Executive Director's Recommendation

Commission Meeting: July 12, 2018

PROJECT US Naval Observatory New Master Clock Facility and Building Rehabilitations US Naval Observatory 3450 Massachusetts Avenue, NW Washington, DC	NCPC FILE NUMBER 7995
SUBMITTED BY United States Department of Defense Department of the Navy	NCPC MAP FILE NUMBER 71.20(38.00)44771
REVIEW AUTHORITY Federal Projects in the District per 40 U.S.C. § 8722(b)(1) and (d)	APPLICANT'S REQUEST Approval of preliminary site and building plans
	PROPOSED ACTION Approve of preliminary site and building plans with comments
	ACTION ITEM TYPE Staff Presentation

Overall Site: Concept Site Plan

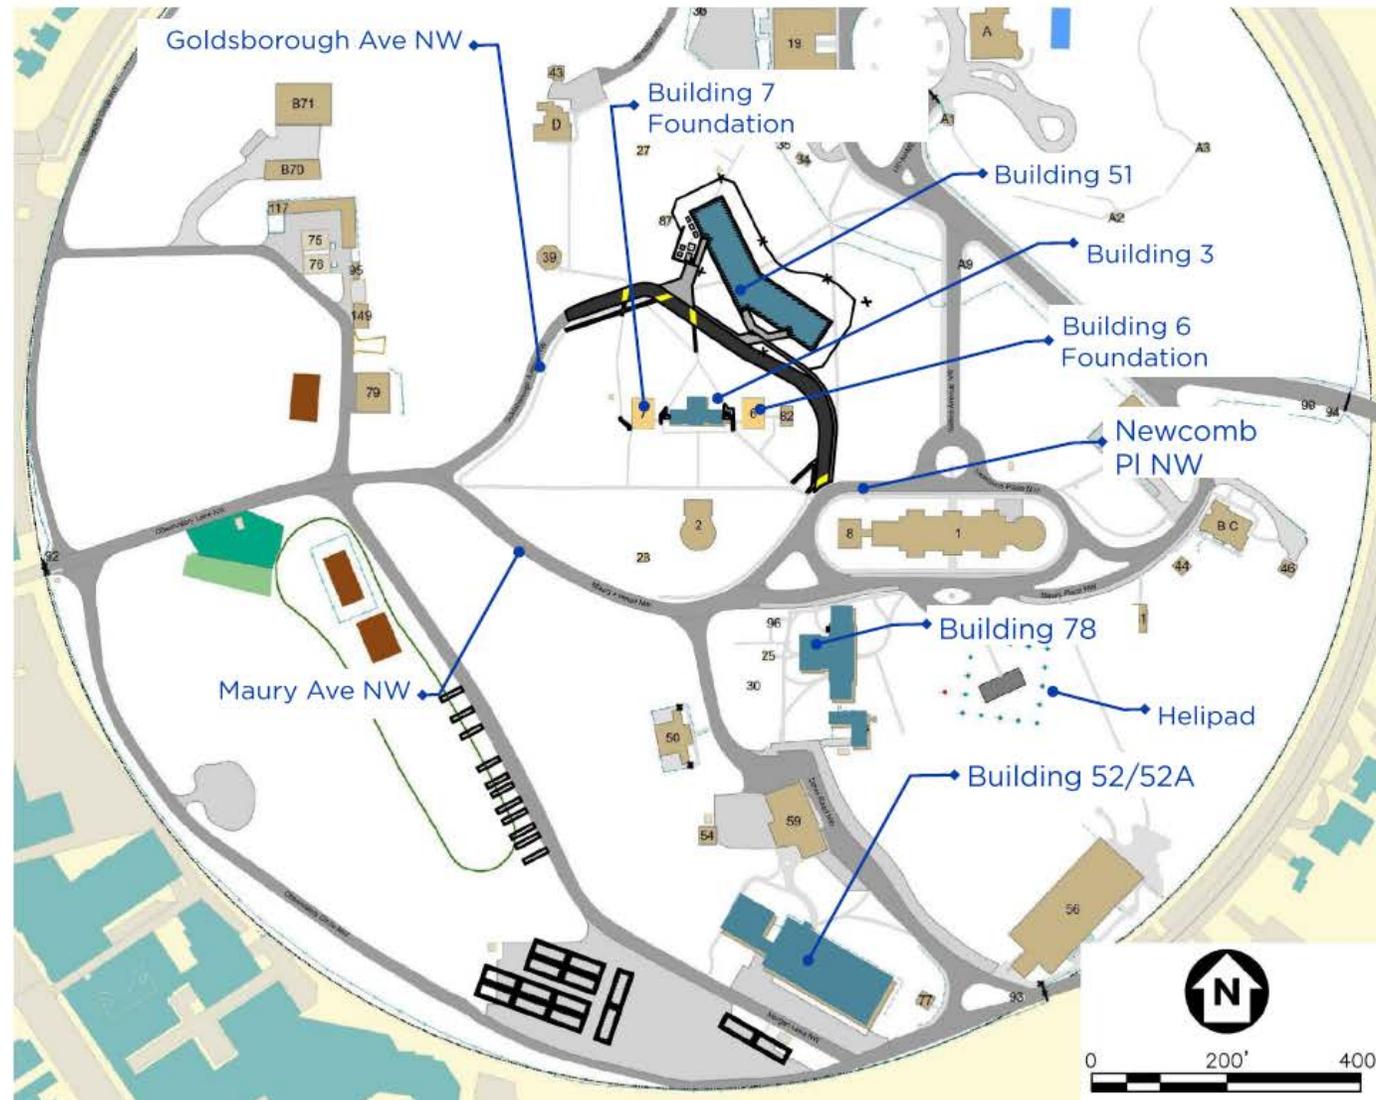
requirements, but asked if the roadway is treated by the adjacent bioretention or bioswale. Since this project is located within the MS4, vehicle access areas are required to have at least 50 percent of the stormwater treated or retained. The applicant has indicated the plan will be submitted to DOEE for stormwater management review and for erosion and sediment control review and it will comply with DC DOEE regulations, which means vehicle access areas are required to have at least 50% of the SWR treated or retained. The rain garden on the front of the building will treat the road runoff and the raingarden in the back is to treat the building. More concrete information on the SWM will be available as the project progresses. The SHPO is coordinating subject to the completion of the ongoing Section 106 review and the development of a memorandum of agreement. The participating agencies were: NCPC; the District of Columbia Departments of Transportation; District of Columbia Department of Energy and Environment; the General Service Administration; the District of Columbia State Historic Preservation Office; the National Park Service; and the Washington Metropolitan Area Transit Authority.

Building 51: Rendered Perspectives

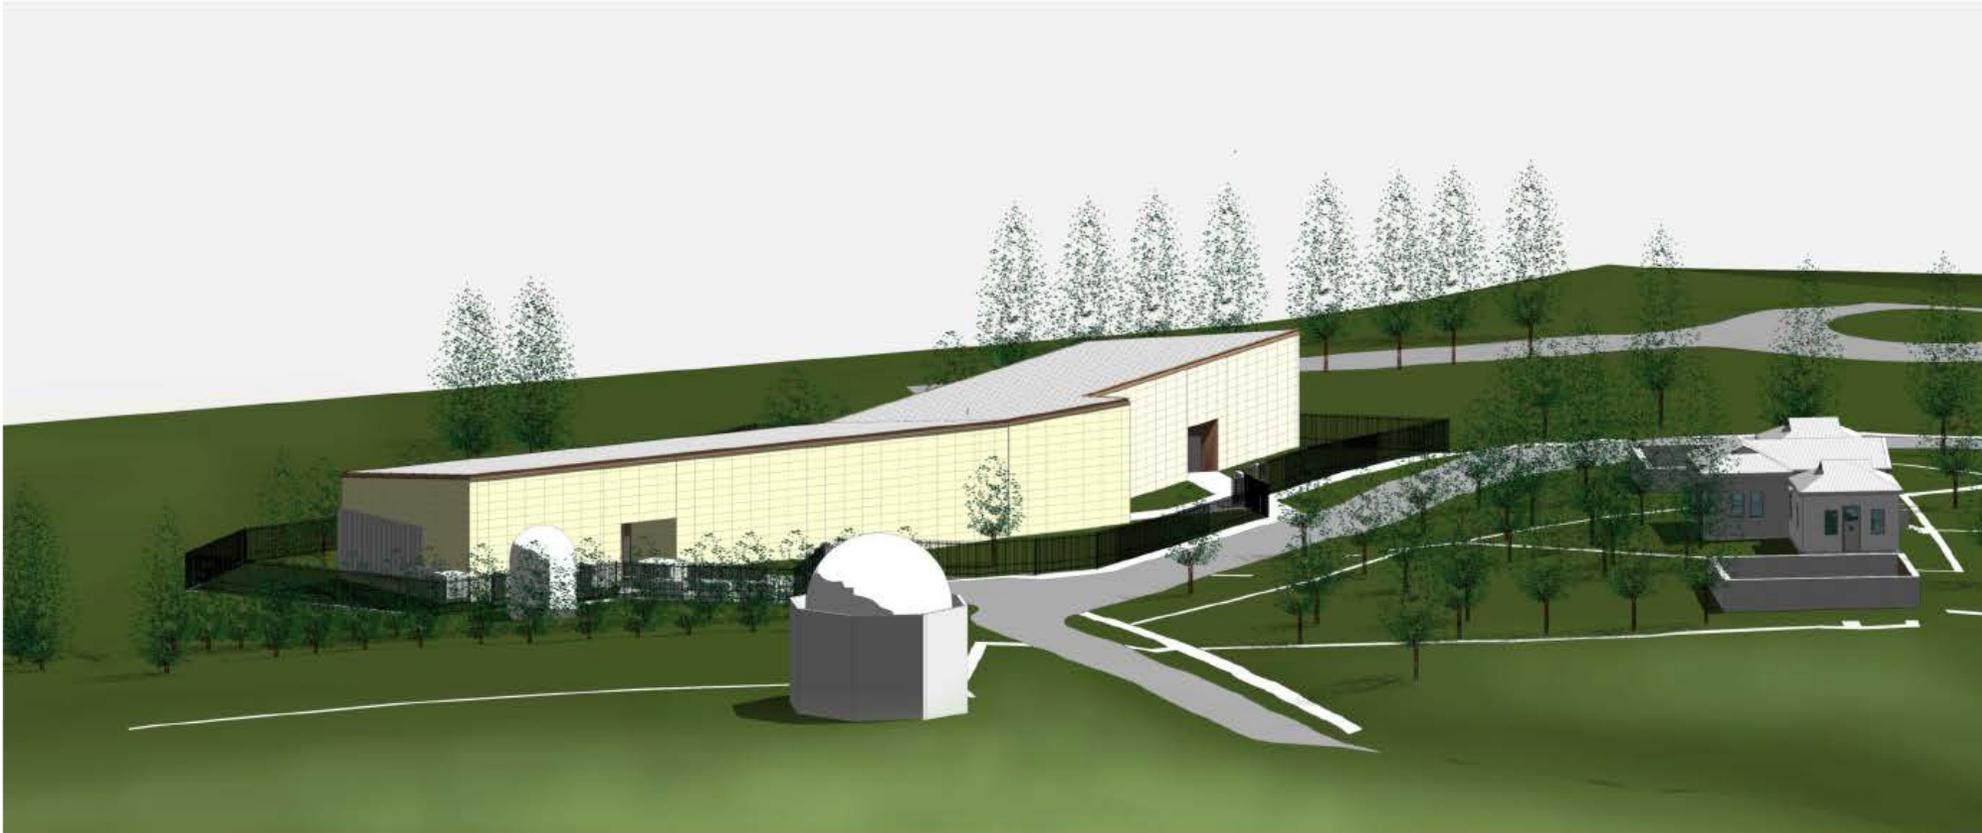
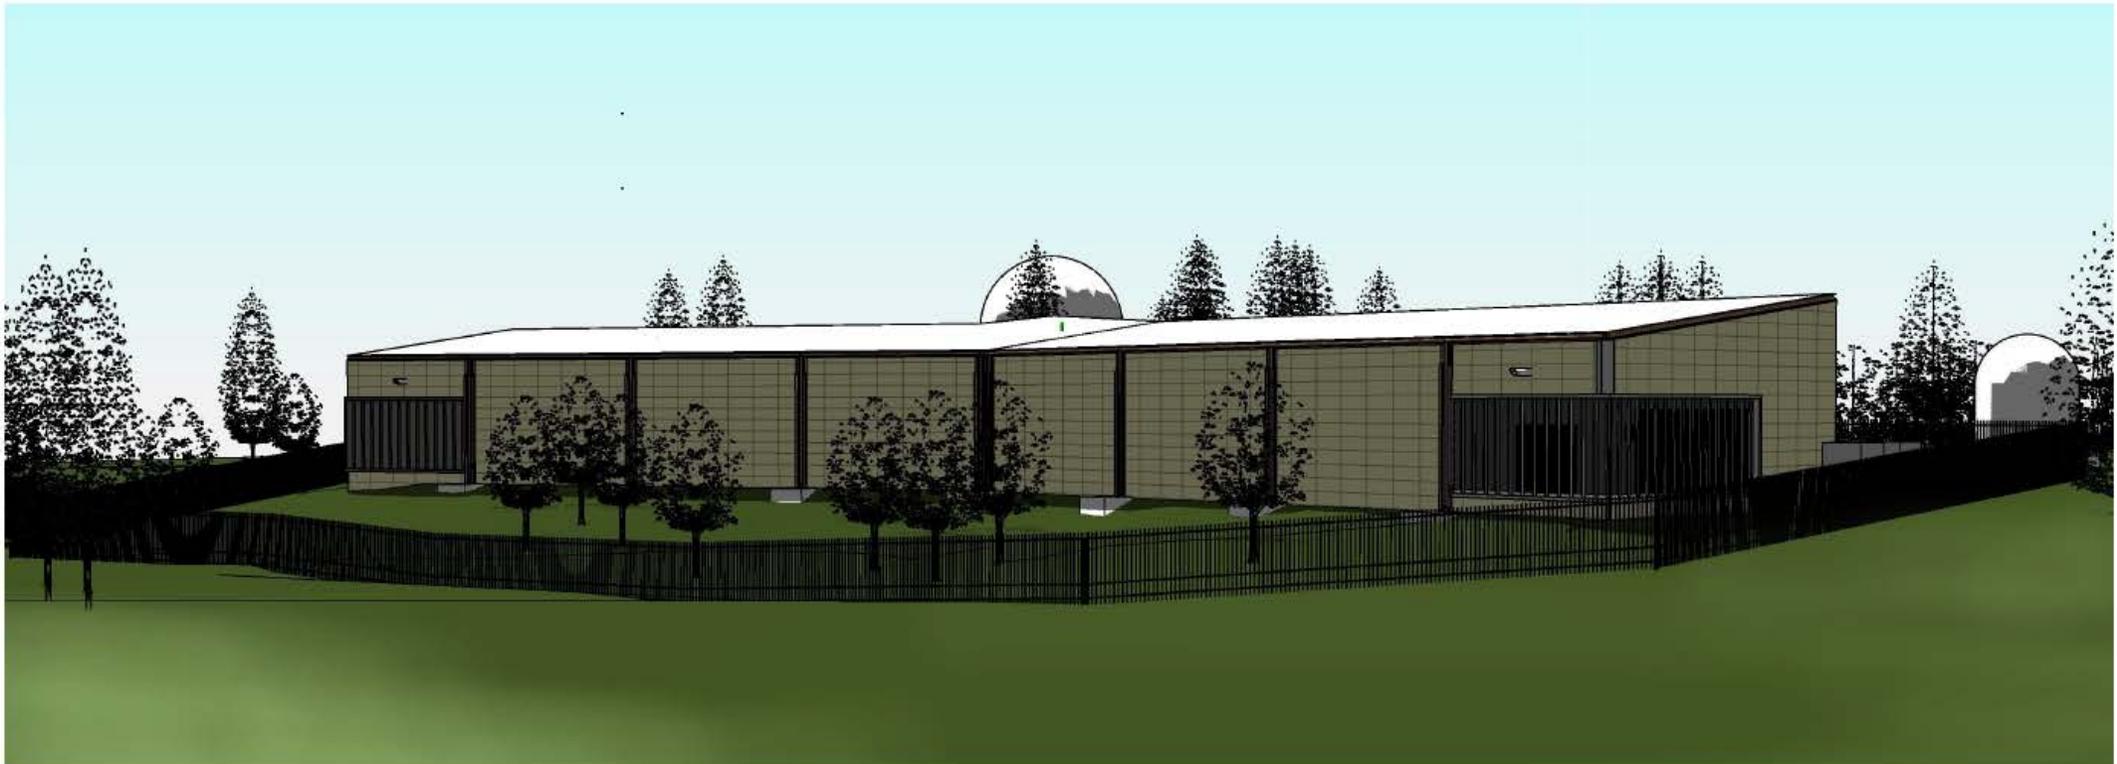
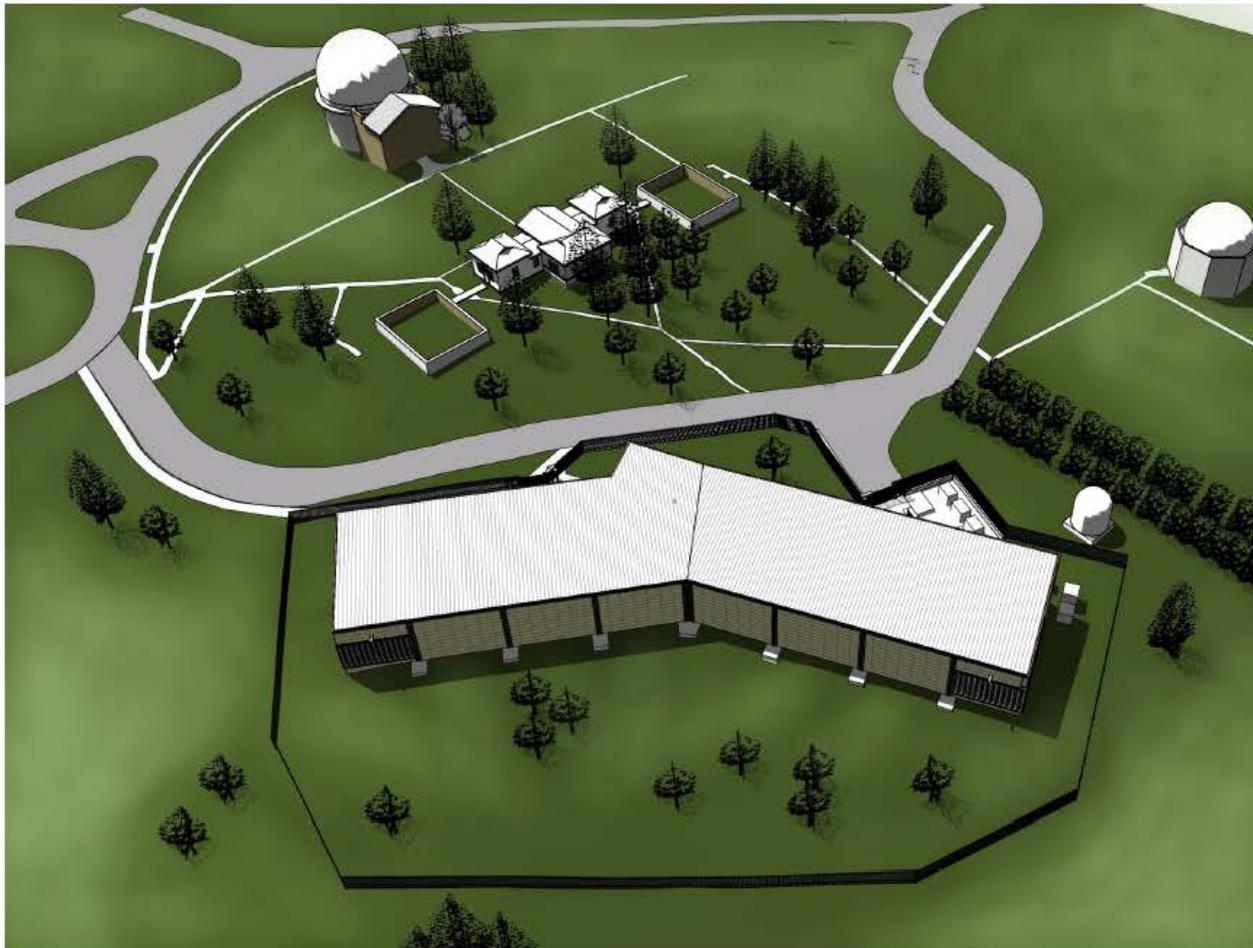
Requests the Department of the Navy provide additional views and perspectives from the north side of the Clock House (Building 3) looking northwest, from the north entrance of Building 1, at the ceremonial drive looking northwest, and from the ceremonial drive at the circle looking northwest.
